Technical Service Information

FORD E4OD WILL NOT HOLD IN PARK

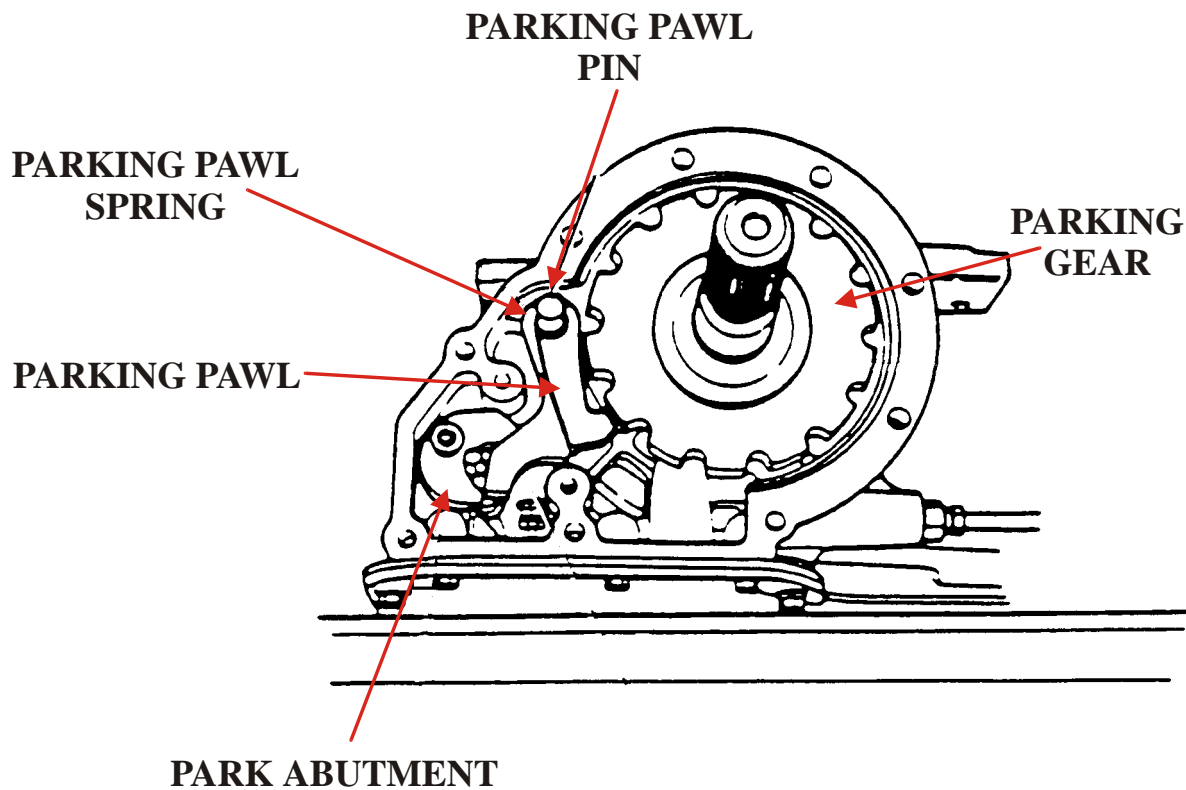
CAUSE: The cause *may* be a broken snap ring on the output shaft, allowing the parking *gear* to move rearward, and then the parking pawl cannot engage into the parking gear (See Figure 1). Action must be taken based on the build date as identified on the transmission I.D. tag. Refer to Figure 2 for build date identification. Ford Safety Recall Number 90S10.

PREVIOUS DESIGN

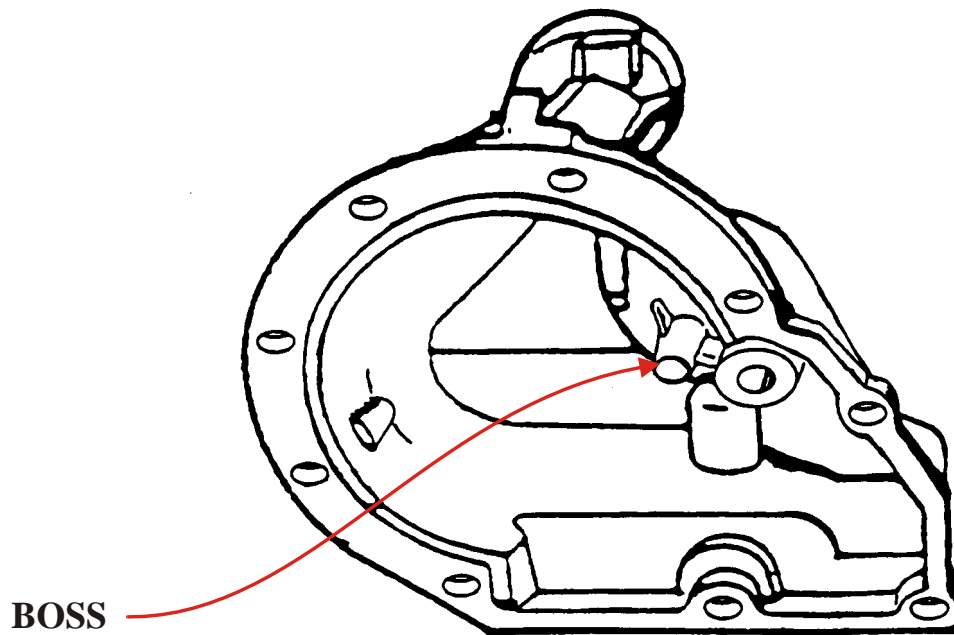
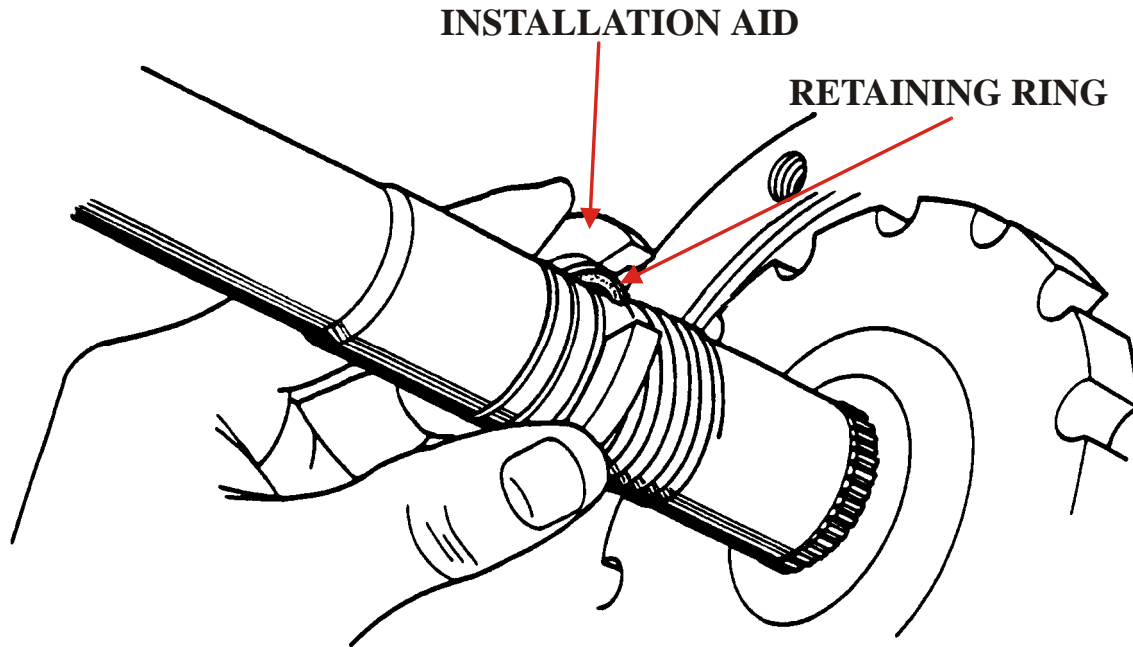
CAUSE: There is now available a new service package, under OEM Part Number F0TZ-7A040-A, that includes a new design extension housing with a new "Boss" cast into it to prevent the parking gear from moving rearward in case the snap ring breaks (See Figure 3). The service package also includes a new "High Strength" snap ring and a snap ring installation aid (See Figure 4). The output shaft has also been re-designed, and has the splines removed from behind the parking gear snap ring groove, which creates an increased shoulder for the snap ring, and helps prevent the snap ring from breaking (See Figure 5). Refer to "Service Information" OEM output shaft part numbers.

E4OD Extension Housing Service Package F0TZ-7A040-A

1. 2nd design extension housing with added boss.
2. New design "High Strength" snap ring.
3. Snap ring installation aid.

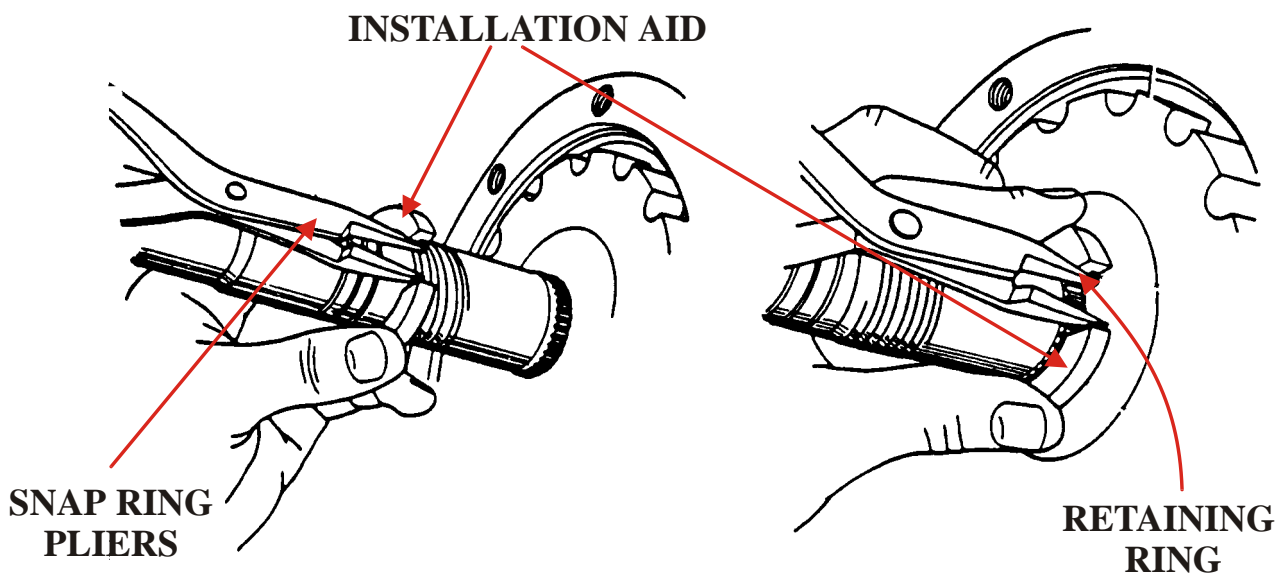
Remove the installing aid with retaining ring from package. Hold the ring in the installation aid opposite opening and place installation aid on the output shaft, just before speed0 teeth, with ring facing transmission. Ring ends must be in installation aid opening. Installation aid is to prevent the ring from being spread too far apart

2. Hold snap ring pliers parallel to output shaft and expand snap ring within the installation aid.

3. Slide snap ring over the speed0 teeth and release the snap ring when the installation aid is against the parking gear. fore speed0 teeth, with ring facing transmission. (Retaining be in installation aid opening). Installation aid is to pre-2.
